Potomac Yard Design Advisory Committee Meeting (PYDAC)

April 18, 2018

SUBJECT: American Physical Therapy Association (Landbay G Block A1)

APTA PYDAC PRESENTATION

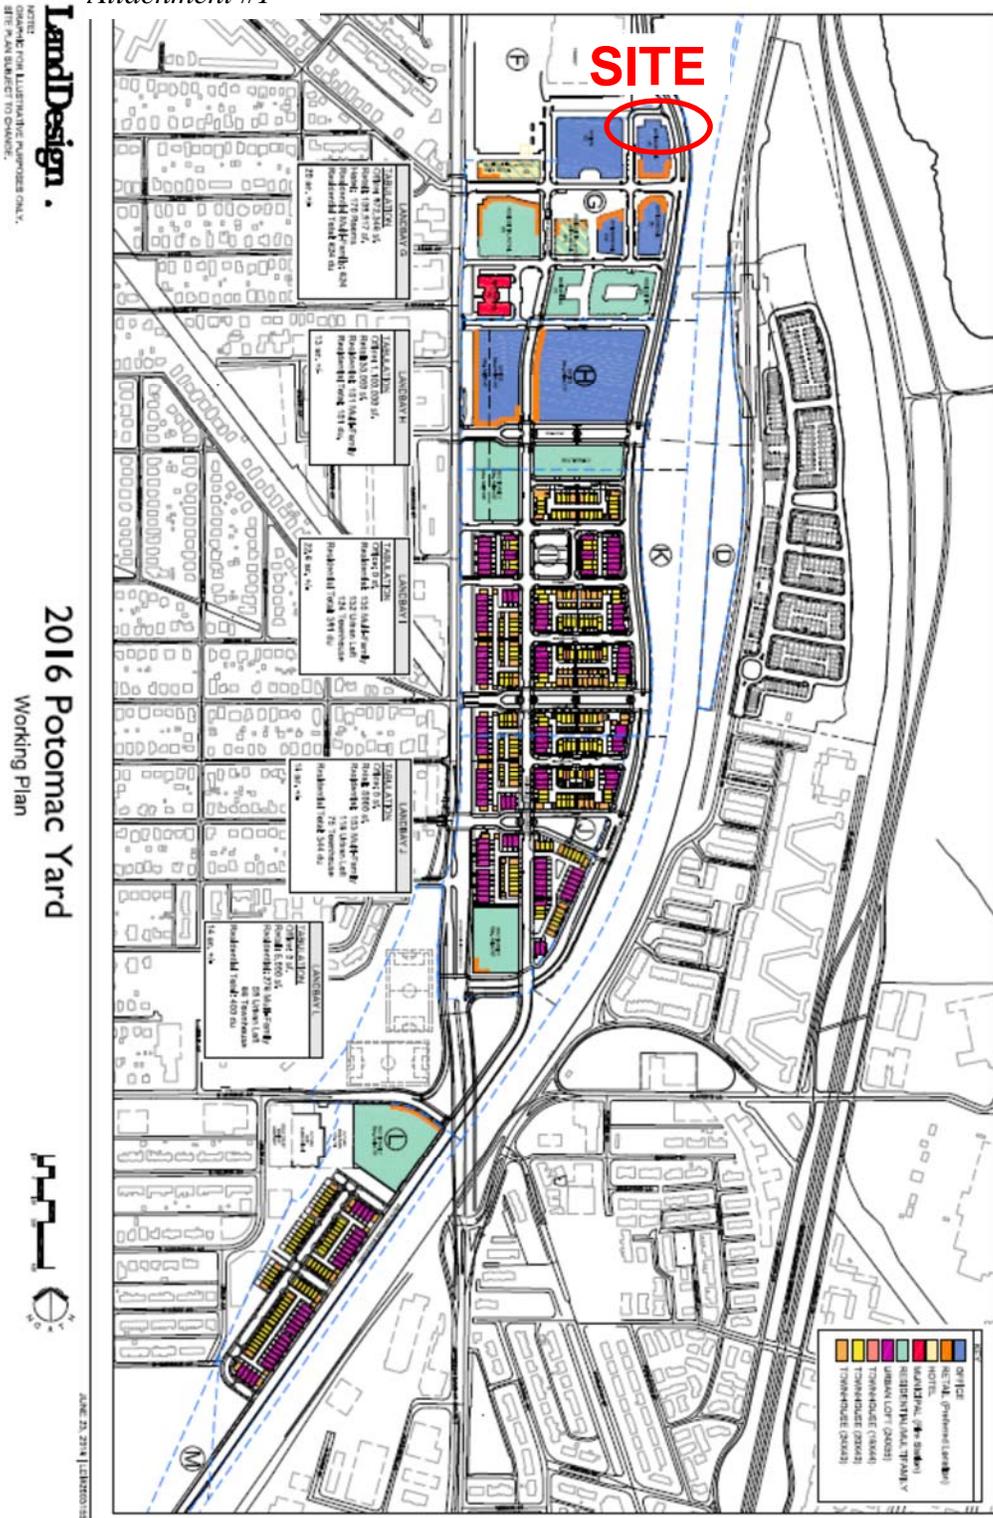
- Further refinements to the entry portal should be studied, in relation to how best to integrate its appearance with the adjacent NIB frontage and how the adjacent building sections “join” at the building line.
- The applicant should study the use of material layer(s) behind the metal scrim that would complement the scrim and accentuate portions of the stair tower in order to de-emphasize its functional appearance and make it more an abstract element.

On the southern façade, converting the lighter Granitex panels to a dark gray color to match the boardroom directly above would help to integrate the boardroom volume with the rest of the building and set the curved façade along Potomac Avenue apart as special.

RETAIL CONTEXT

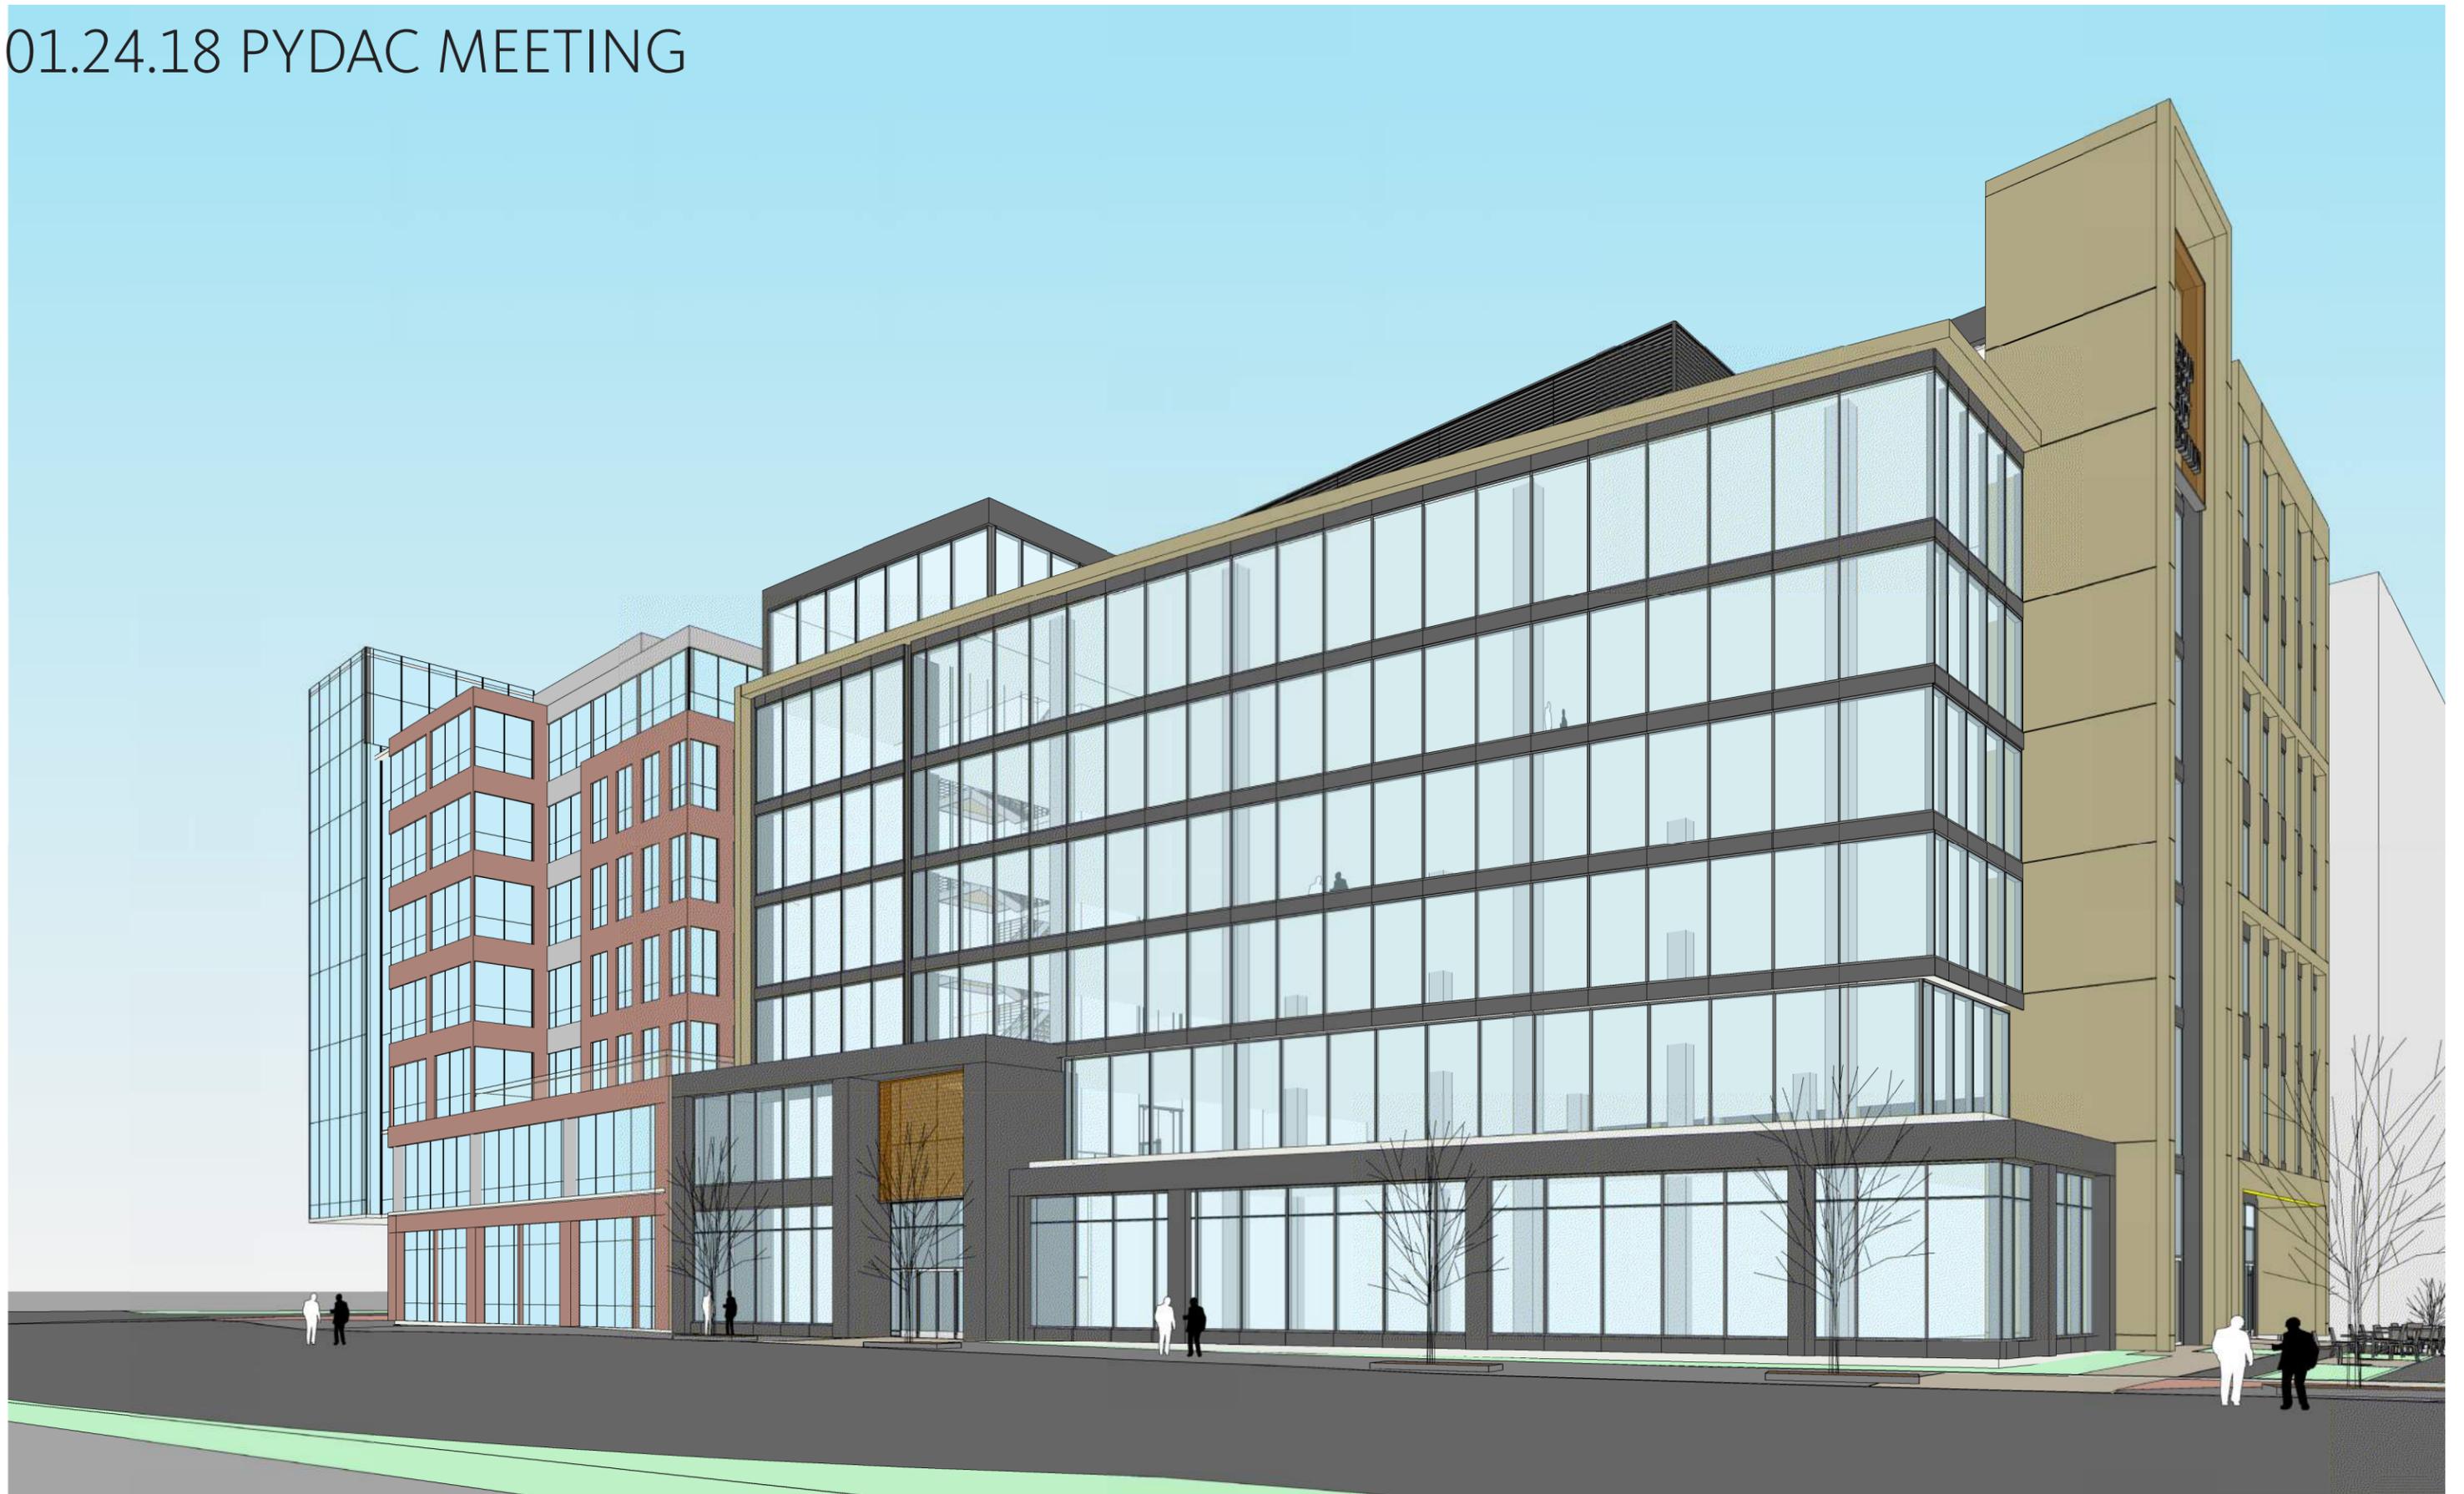
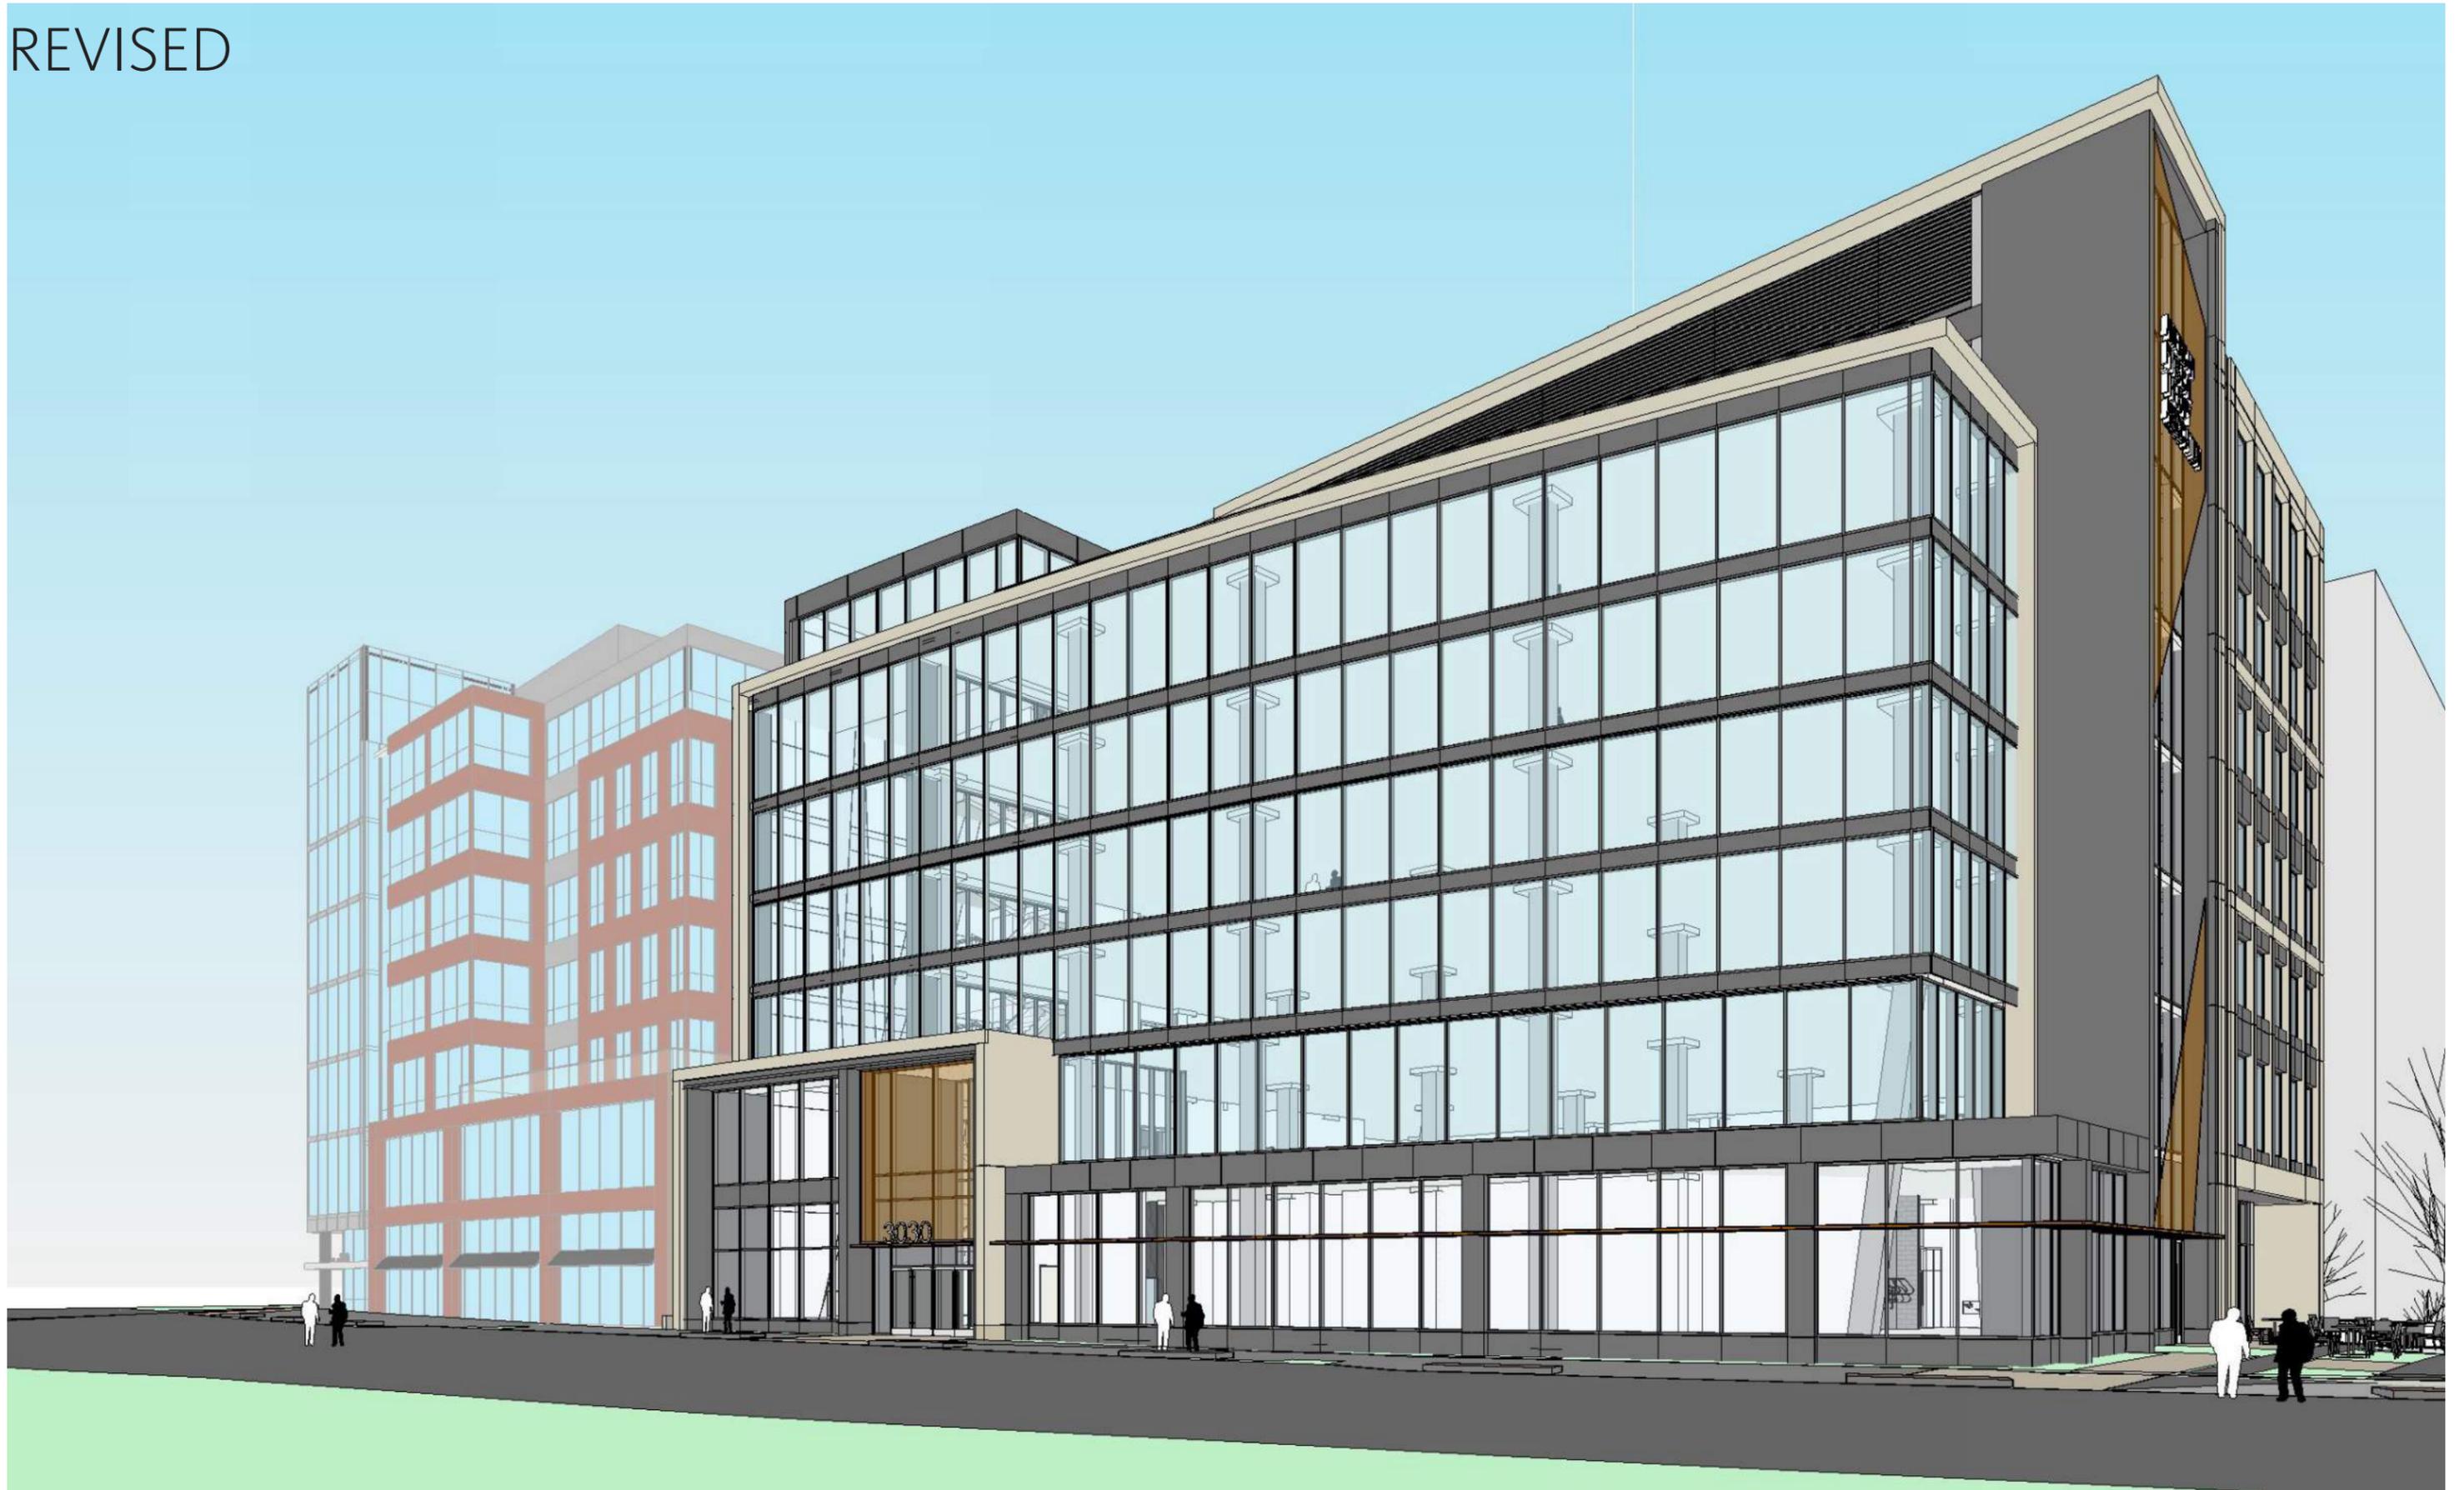
- Strengthened the entrance portal on Potomac Avenue to create a clear transition from NIB to APTA
- Provided deeper setback of the level 07 boardroom to further express the east façade curvature along Potomac Ave
- Added sunshade at ground floor to add pedestrian scale to the Potomac Avenue facade
- Enhanced northern elevation to celebrate the staircase and add visual interest in the highly visible façade
- Modified the color scheme to lighten the coloring while maintaining compatibility with the adjacent NIB and IDA buildings
- Revised materials on southern façade adjacent to NIB
- Located transformer vault beneath Dogue Street to avoid impacts on plaza
